Project	<b>IEEE 802.16 Broadband Wireless Access Working Group</b> < <a href="http://ieee802.org/16">http://ieee802.org/16</a> >	
Title	<b>Add Set operation Type to LBS primitvies</b>	
Date Submitted	<b>01/12/2007</b>	
Source(s)	Jeff Qian and Cancan Huang	<a href="mailto:jqian@zteusa.com">jqian@zteusa.com</a>
	ZTE	<a href="mailto:chuang@zteusa.com">chuang@zteusa.com</a>
Re:	Contribution on comments to IEEE 802.16g/D6	
Abstract	Add Set operation Type to LBS primitvies	
Purpose	Adoption	
Notice	This document has been prepared to assist IEEE 802.16. It is offered as a basis for discussion and is not binding on the contributing individual(s) or organization(s). The material in this document is subject to change in form and content after further study. The contributor(s) reserve(s) the right to add, amend or withdraw material contained herein.	
Release	The contributor grants a free, irrevocable license to the IEEE to incorporate text contained in this contribution, and any modifications thereof, in the creation of an IEEE Standards publication; to copyright in the IEEE's name any IEEE Standards publication even though it may include portions of this contribution; and at the IEEE's sole

Figure 514— -LBS Management Primitives

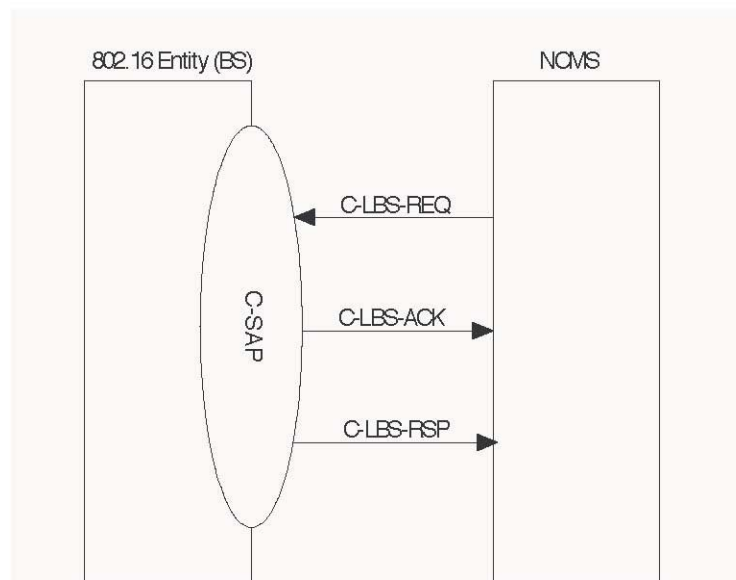
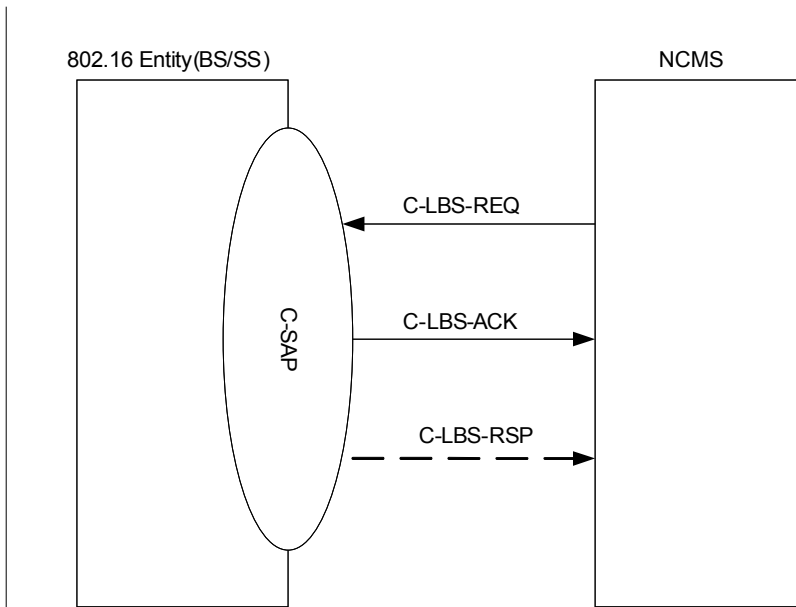
In current LBS primitive definitions, it only has GET operation type been defined. But in different LBS schemes, the LBS SET operation is also needed. It can be used to pass necessary LBS related parameters into corresponding LBS related network entities. The other change is to include SS as 802.16 Entity since LBS primitive will have interface with SS too.

*[Modify subclause 14.1.11 as follows]*

The NCMS manages the LBS capabilities that are implemented in the BS and the MS. LBS Management sub clause provides a set of primitives for NCMS to retrieve parameters that are required for supporting LBS. Figure 517 depicts the LBS Management primitives.

Operation Type	Description
Get	LBS parameters
<u>Set</u>	<u>LBS related configuration Info</u>
